ACCESSION NBR: 9708010147 DOC. DATE: 97/07/18 NOTARIZED: YES DOCKET #
 FACIL: STN-50-528 Palo Verde Nuclear Station, Unit 1, Arizona Publi 05000528
 STN-50-529 Palo Verde Nuclear Station, Unit 2, Arizona Publi 05000529
 STN-50-530 Palo Verde Nuclear Station, Unit 3, Arizona Publi 05000530

SUBJECT: Responds to 970422 RAI re improved TS Section 3.4, "RCS." Proposed TS encl.

Response to Request for Additional Information

Figure 3.4.3-1
Reactor Coolant System Pressure/Temperature
Limitations for Less Than 8 Effective
Full Power Years of Operation

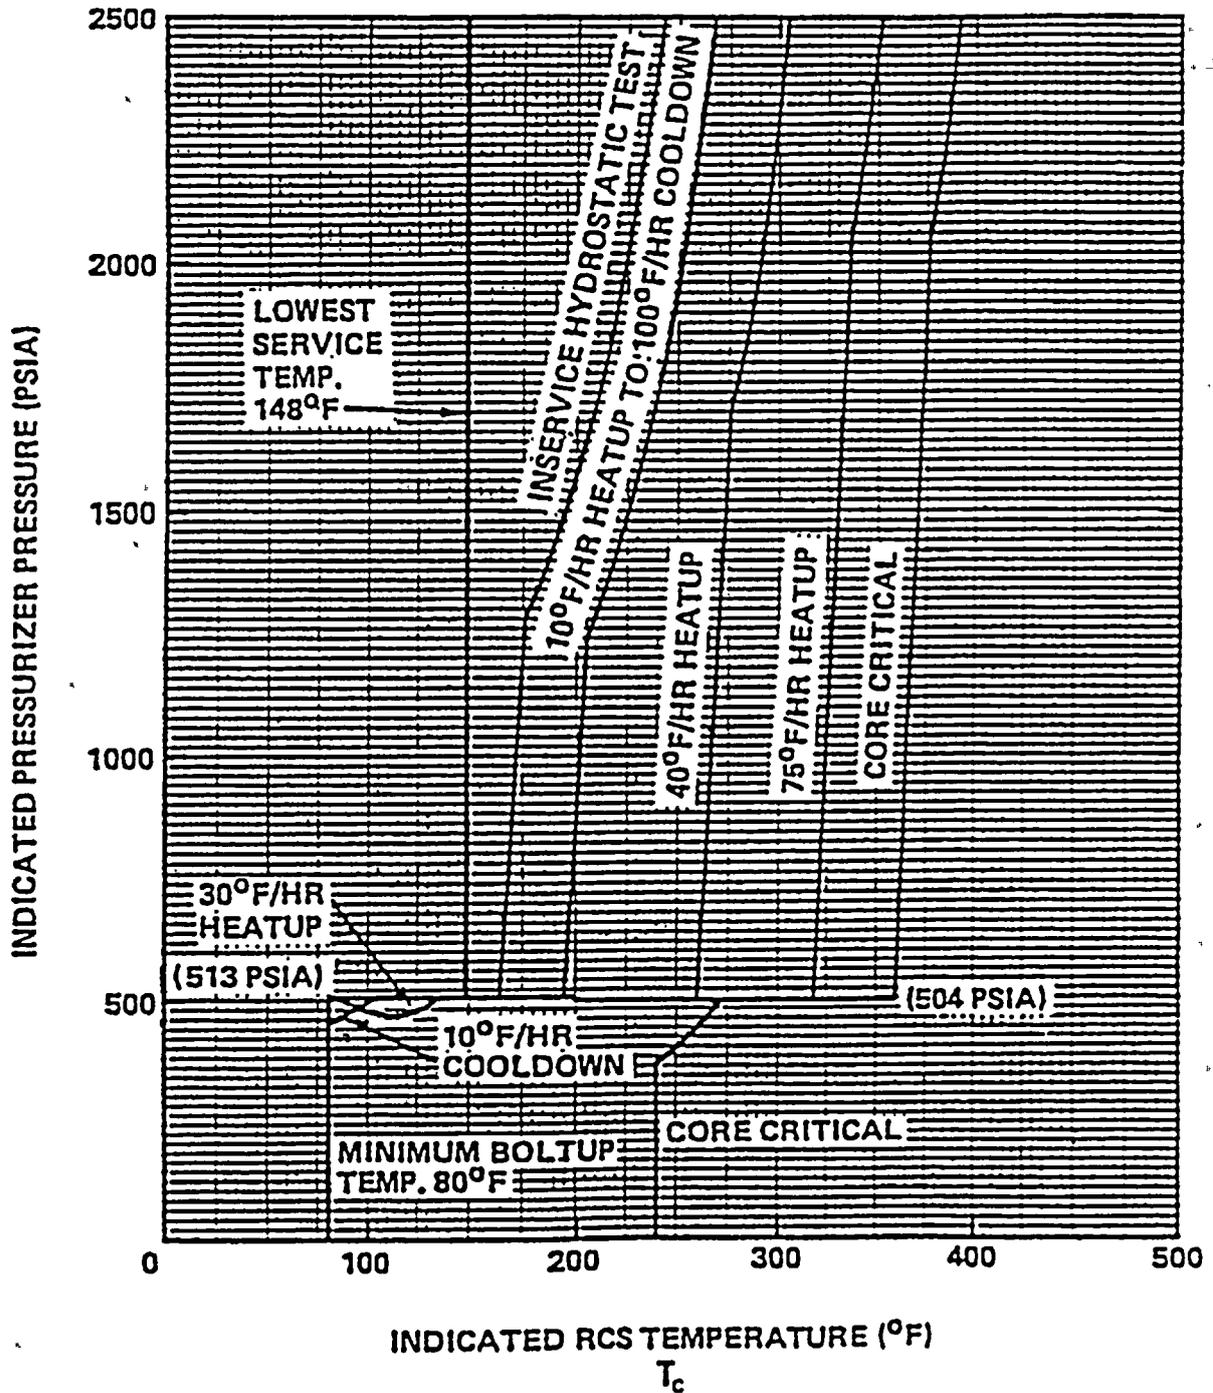
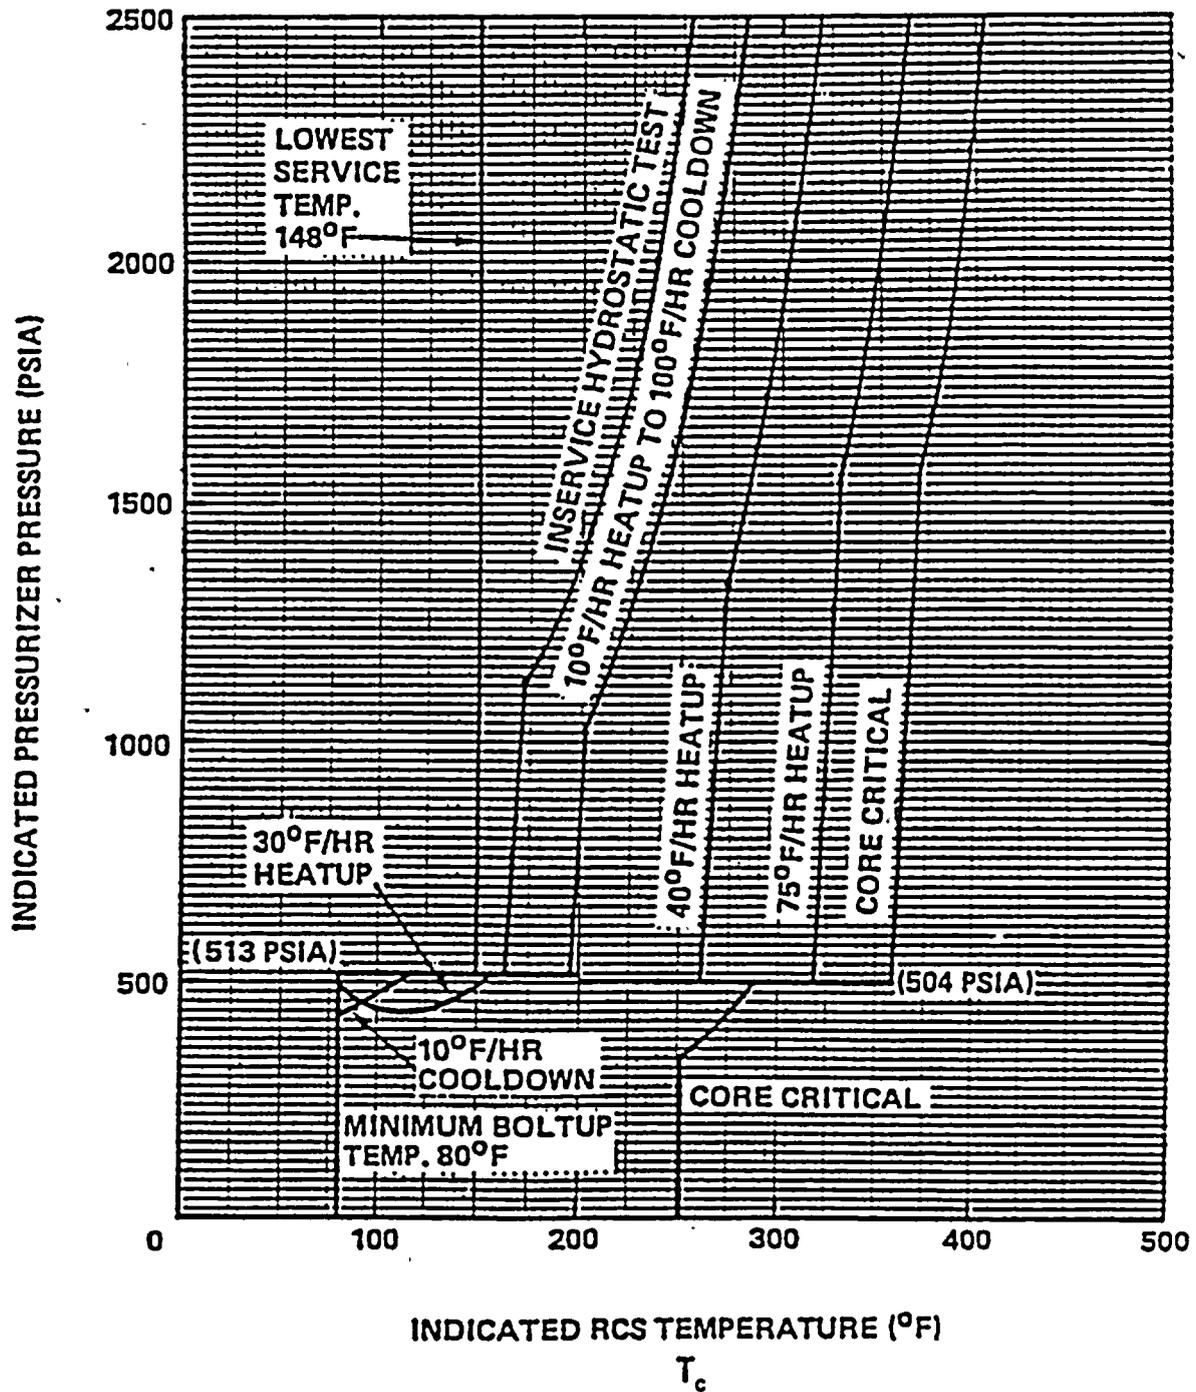
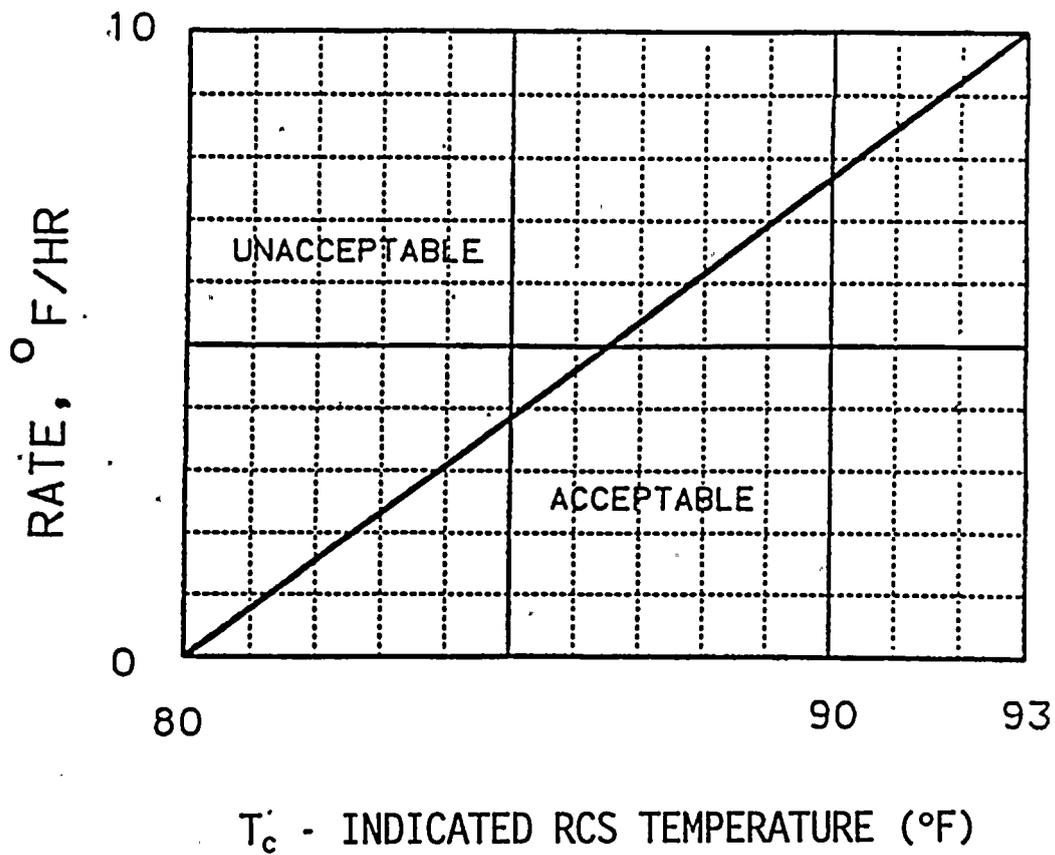
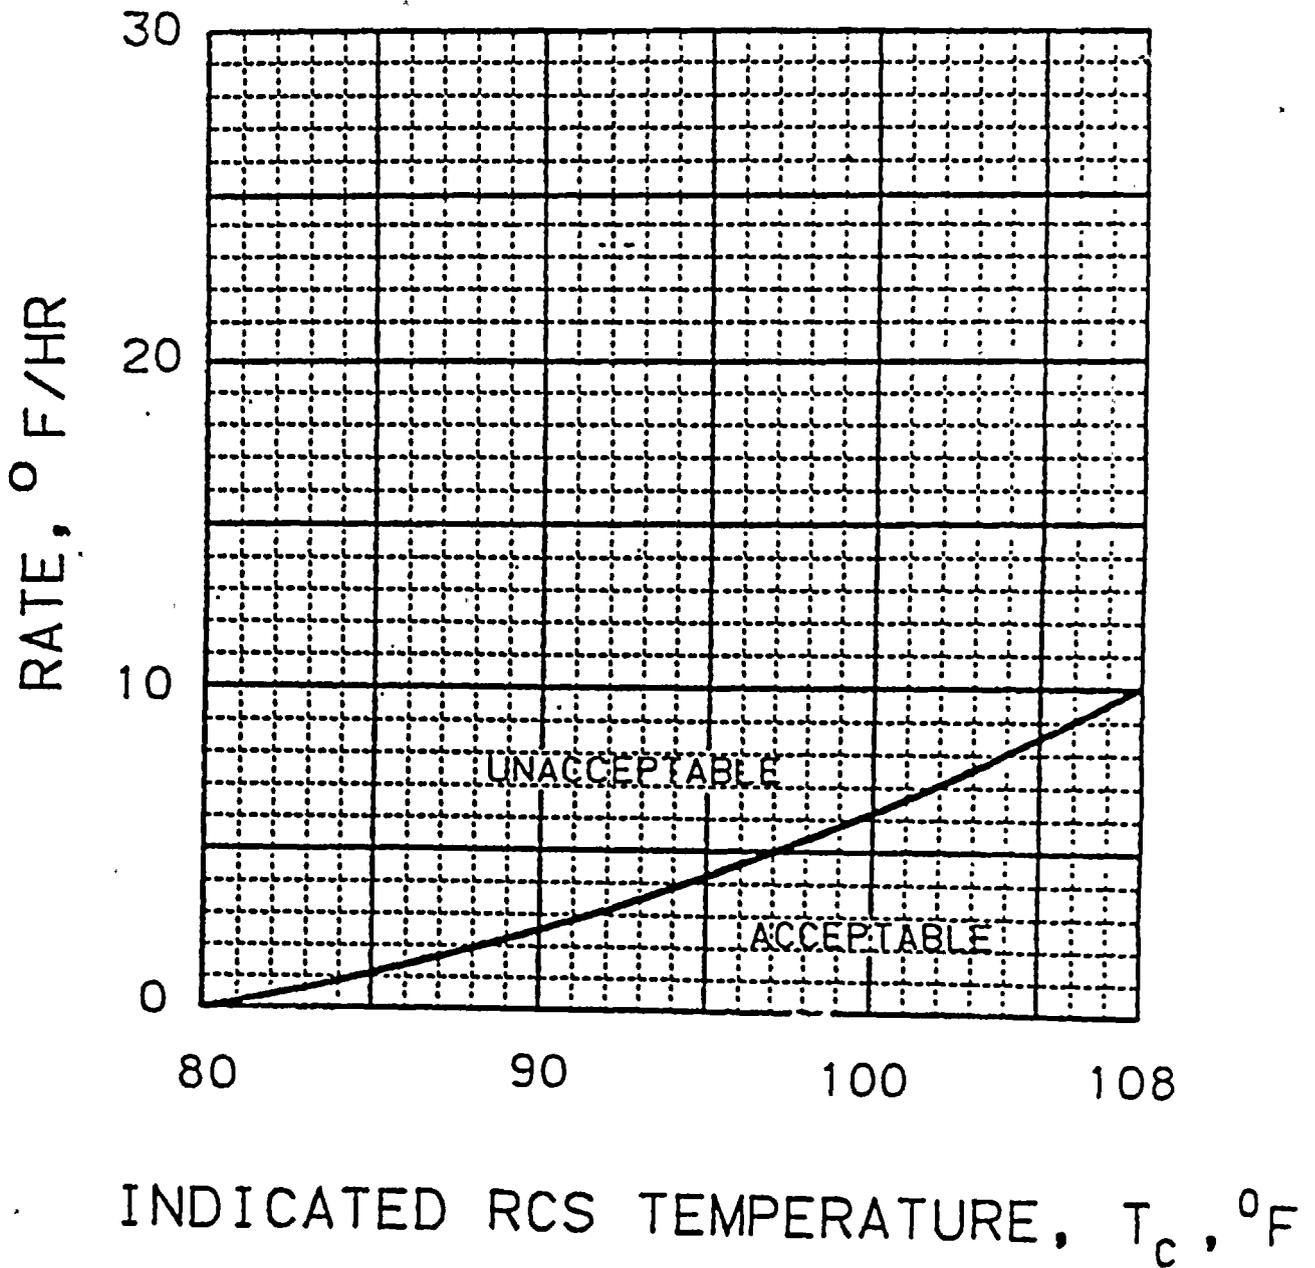
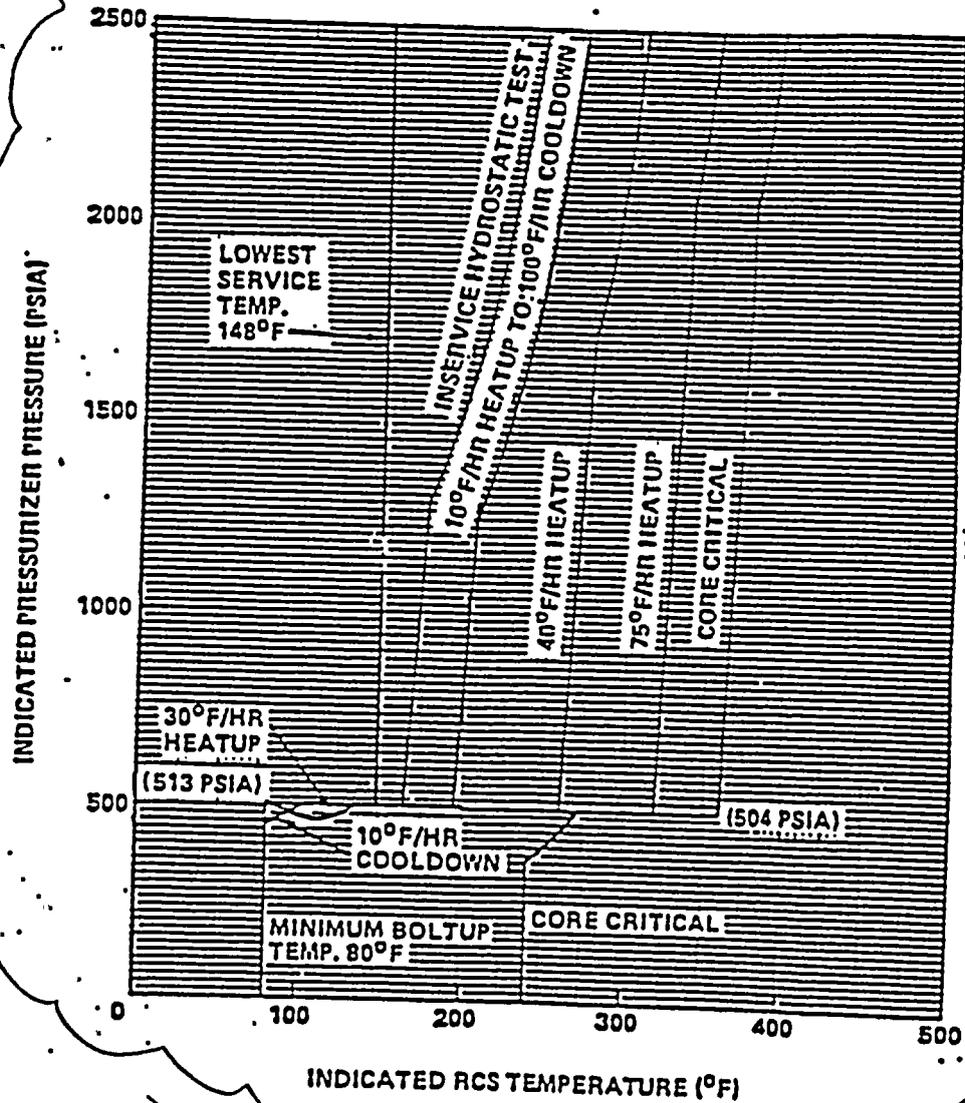
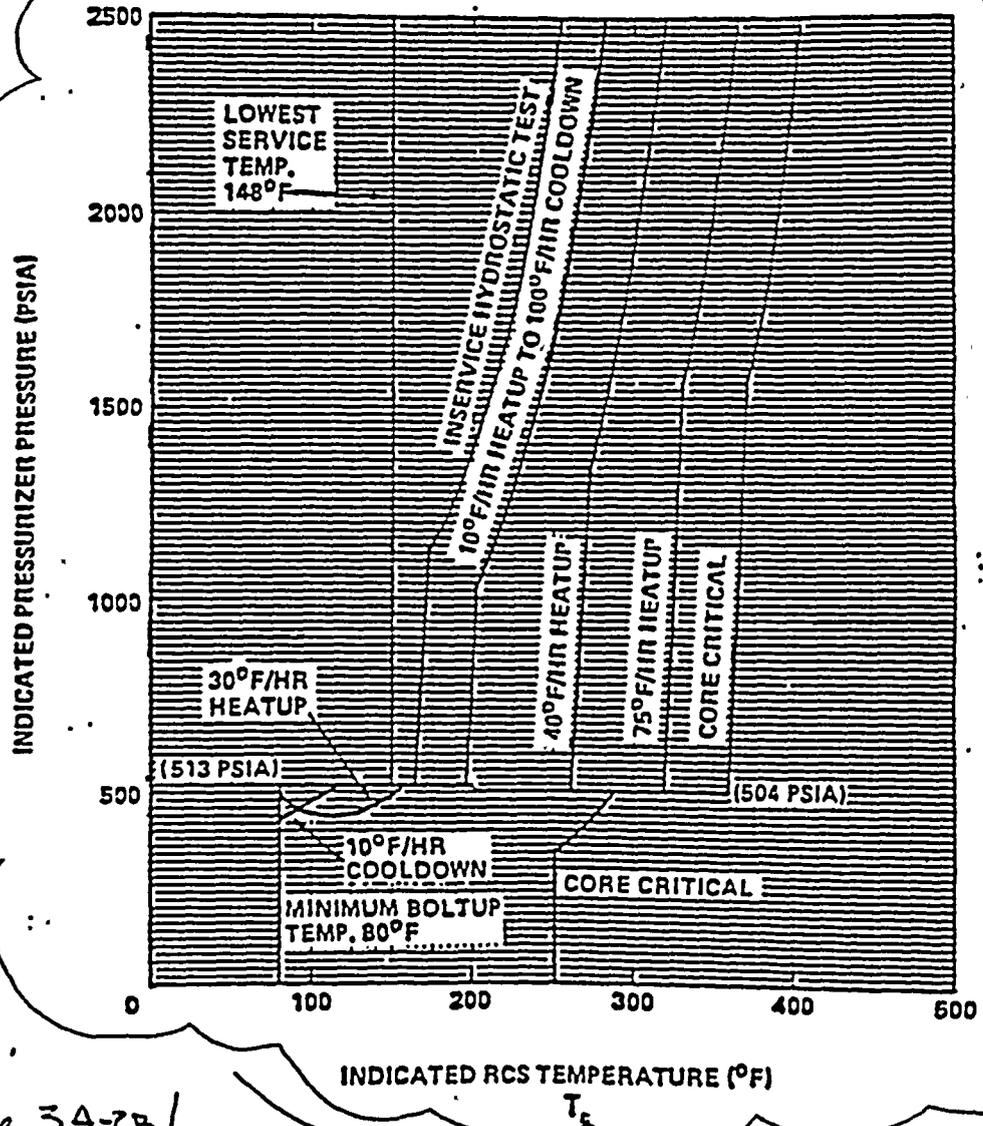
ISSUE #	DOC # or JFD #	CTS/STS REF	DESCRIPTION OF ISSUE	PVNGS RESPONSES
3.4.3-2	JFD #2	ITS Figures 3.4.3-1, -2, -3, &-4	<p>These CTS Figures have been recreated for the ITS and there are errors and differences. The minimum temperature for boltup is now 30°F; the lower "core critical" is not connected to the line by being attached (as it is in CTS) or by an arrow. Therefore, it is unclear whether it is referring to the line or the region to the right of the line.</p> <p>Comments: Revise the Figure to match the CTS requirements.</p>	ITS Figures 3.4.3-1, 3.4.3-2, 3.4.3-3, and 3.4.3-4 have been revised to accurately reflect their corresponding CTS figures, CTS Figures 3.4-2a, 3.4-2b, 3.4-2c, and 3.4-2d, respectively.
